802.3dj D1.0

Comment Resolution

Common Topics

Matt Brown (Alphawave Semi), 802.3dj Chief Editor
Leon Bruckman (Huawei)
Gary Nicholl (Cisco)
Adee Ran (Cisco)

Figure 176A-9—Coefficient update state diagram

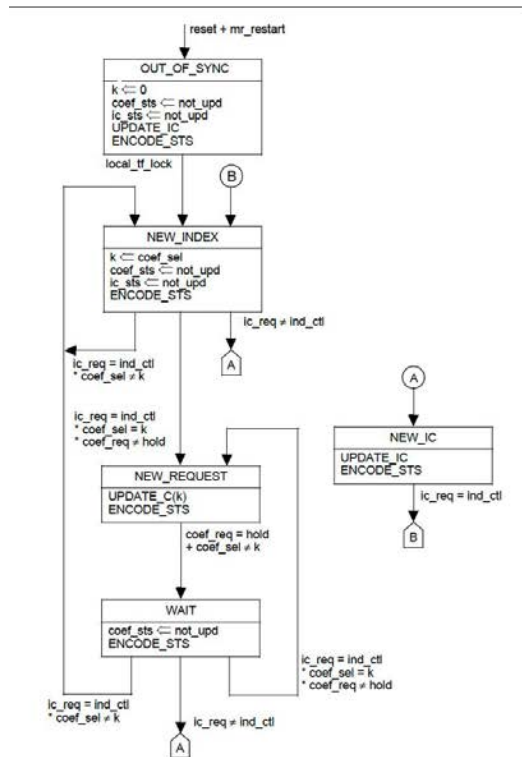
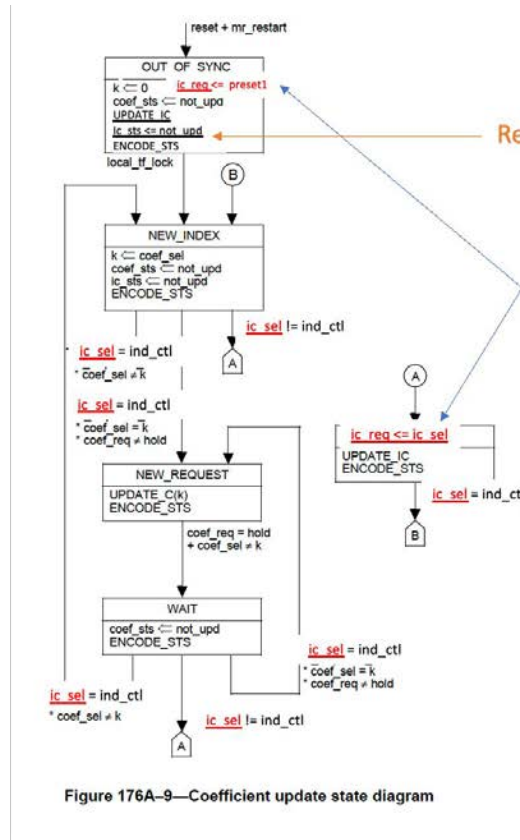
The UPDATE_IC function is called in the OUT_OF_SYNC state of the Figure 176A.9 Coefficient update state diagram. The UPDATE_IC function uses the ic_req variable to set the coefficients (see 176A.6.2), and the ic_req variable is derived from the 'initial condition request' bits from the control field of the received training frames (see 176A.10.3.1).

Since, however, the OUT_OF_SYNC state is entered during reset (reset or mr_restart set true), it would seem unlikely that training frames are being received. If that is the case, it isn't clear what the value of the ic_req variable is, and therefore what the coefficients should be set to.

176A.6.2 says that 'The transmitter equalizer is set to preset 1 upon entry to the QUIET state of the interface control state diagram.'. Since the QUIET state of the Interface control state diagram is also entered during reset, it seems the coefficients should be set to preset 1 when the Coefficient update state diagram is in the OUT_OF_SYNC state.

The comment is pointing out that the initial condition of the ic_req variable is not explicitly defined and there could be startup issue if PRESET1 is chosen over ind_sel as the default state.

- [1] Delete the first sentence of the ic_req definition in 176A.10.3.1.
- [2] Add the text 'If the Coefficient update state diagram is in the OUT_OF_SYNC state ic_req is set to preset 1. Otherwise, it is derived from the "initial condition request" bit of the control field of received training frames on the correspondent lane of the interface.' to the end of the ic_req definition in 176A.10.3.1.

Rename and create a new `ic_req`

~~`ic_req`~~ `ic_sel`

Enumerated variable derived from the “initial condition request” bits from the control field of the received training frames (see 176A.3). This variable may be assigned one of the following values (abbreviations used by the state diagram are included in parentheses): individual control (`ind_ctl`), preset 1, preset 2, preset 3, preset 4, preset 5.

`ic_req`

Variable that stores the most recent version of `ic_sel`.

Figure 136-3—Training frame structure

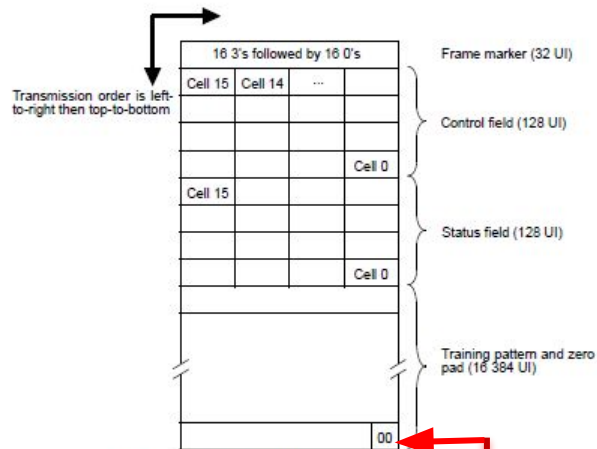
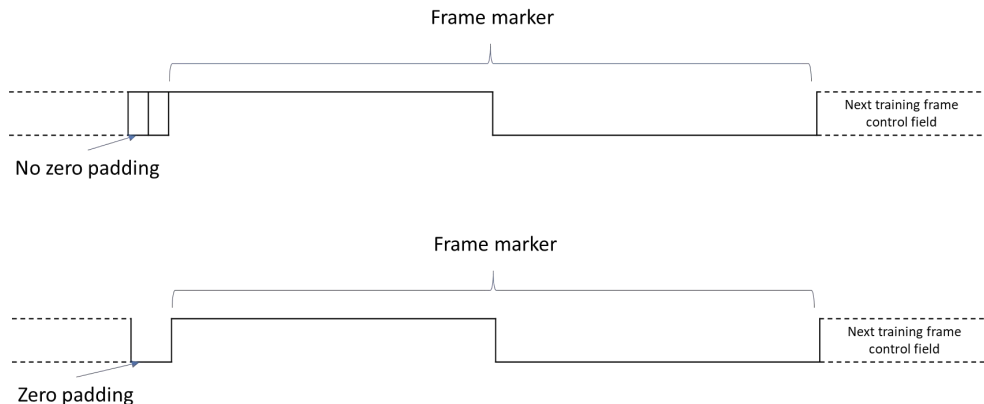
There is no zero pad for PRBS31 free-running. This means we could have a run length of 31 3's in a row when the maximal run length of the PRBS pattern runs into Frame Marker. The Zero pad is really part of the Framer Marker ensuring there is a distinct edge ahead of 16 UI run 3's for the start of the frame marker.

As of D1.0, these pad symbols are not present in the training frame if the test pattern is free-running PRBS13 or PRBS31.

Bring the zero-pad back into the definition of the training frame. Stating that it is immediately precedes the training frame marker to provide a distinct transition from training pattern to frame marker of the next training frame.

176A.2.3 Training pattern

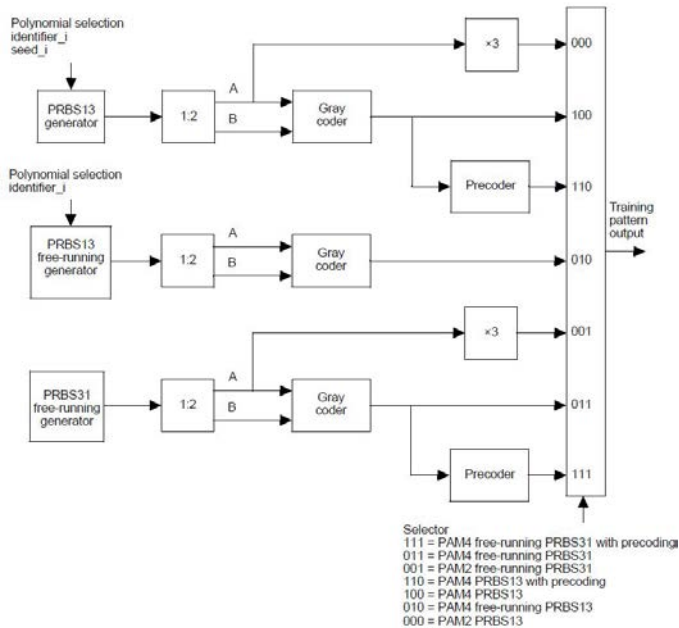
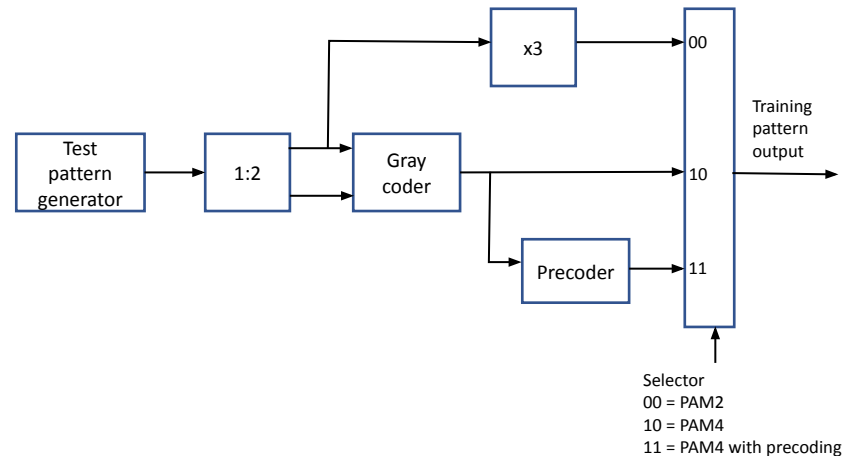
Training pattern options have been added to give receiver additional flexibility to successfully complete training. However, that flexibility is limited by a menu of fixed combinations of encoding and test pattern options. It would be better if encoding and test pattern selections were separated to allow receivers to request whatever combination best suits their needs. There is space in the control and status field structures to accommodate this.

The training pattern is the result of a training pattern generator equivalent to the structure shown in Figure 176A–2.

There are three test pattern generator functions: PRBS13, PRBS13 free-running, and PRBS31 free-running.

The test pattern can be PAM2 or PAM4 modulated. For PAM4 modulation, precoding can be enabled or disabled.

The test pattern selector is set to PRBS13 and the modulation to PAM2 upon entry to the QUIET state of the interface control state diagram (see Figure 176A–6).

NOTE—Exiting TRAINING mode requires both sides to use PAM4 modulation, thus the modulation and precoding request and status are both required to have values other than PAM2.

Figure 176A-6—Interface control state diagram

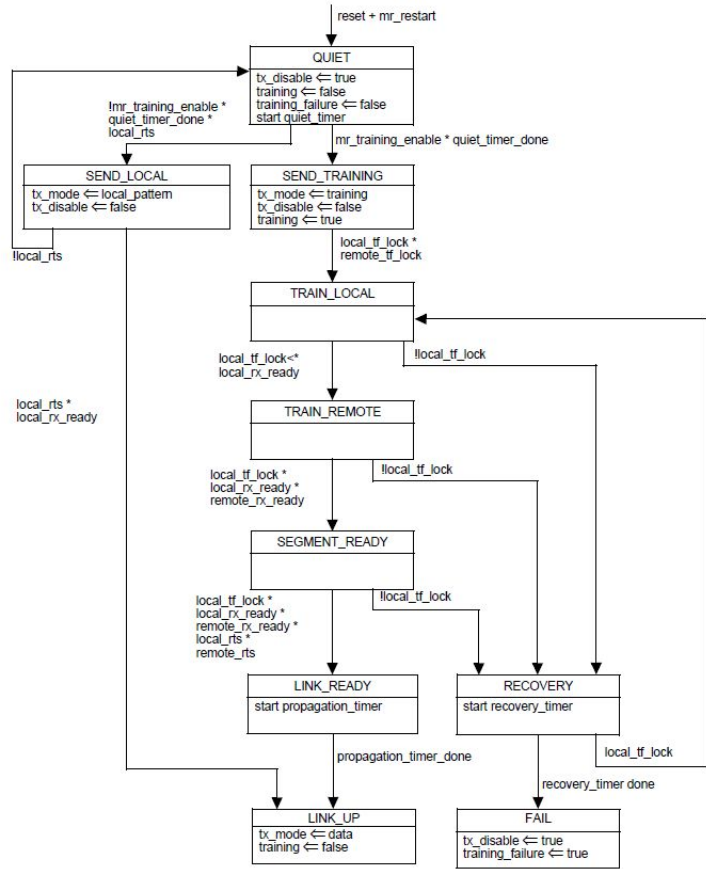
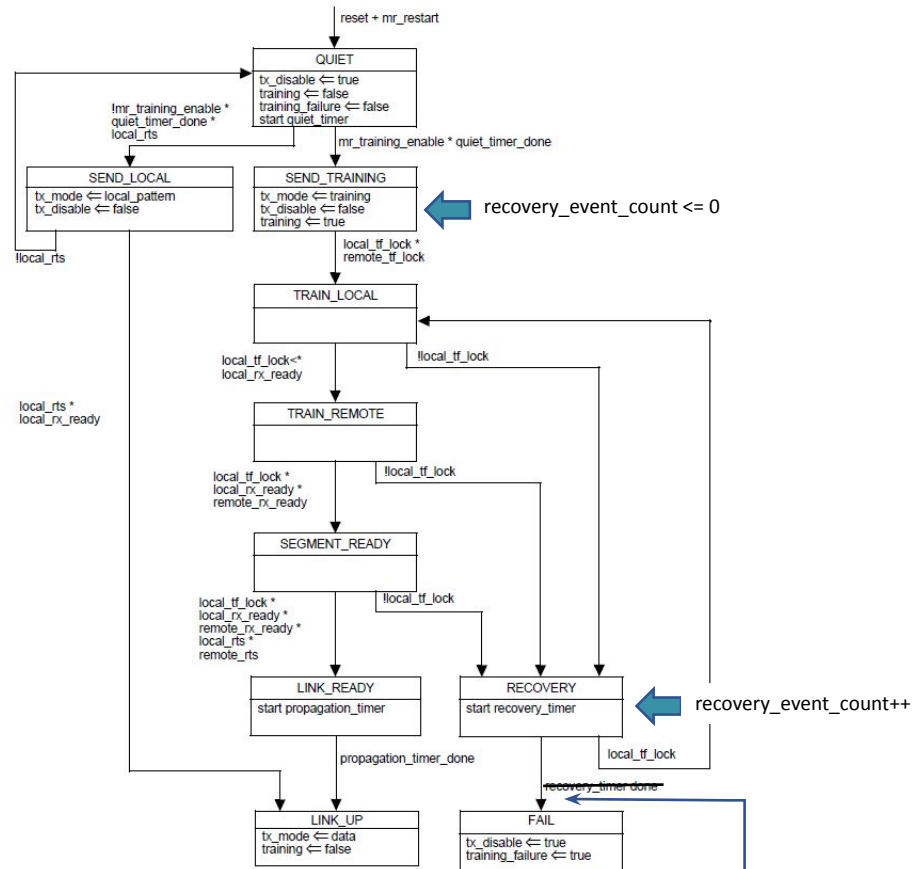
The comment refers to Figure 176A-6 Interface control state diagram. The RECOVERY state coupled with the absence of timeouts, introduces a new challenge in identifying marginal performance cases. These cases may lead to repeated transitions between TRAIN_LOCAL/TRAIN_REMOTE/SEGMENT_READY state to/from RECOVERY state in scenarios of alternating local_tf_lock. A possible solution is to limit the number of RECOVERY events by counting and limiting the number of transitions to the RECOVERY state.

Change `recovery_timer done` to `recovery_timer done || recovery_event_count > X`, where X is 5 (or to be determined).

The suggested change has merit, but the suggested threshold of 5 is somewhat arbitrary. Depending on implementation, other thresholds may be preferred, or this condition may be disabled, without affecting interoperability.

"`max_recovery_events`. Integer variable that controls the maximum allowed number of transitions into the RECOVERY state in the Interface control state diagram (Figure 176A-6). A value of zero allows unlimited number of transitions. The value of this variable is implementation dependent."

"`recovery_event_count`. This counter increments each time the control state diagram (see Figure 176A-6) transitions into the RECOVERY state."

Change "`recovery_timer done`" to "`recovery_timer done + (max_recovery_events != 0)*(recovery_event_count >= max_recovery_events)`".

recovery_timer done +
 (max_recovery_events != 0) * (recovery_event_count >= max_recovery_events)
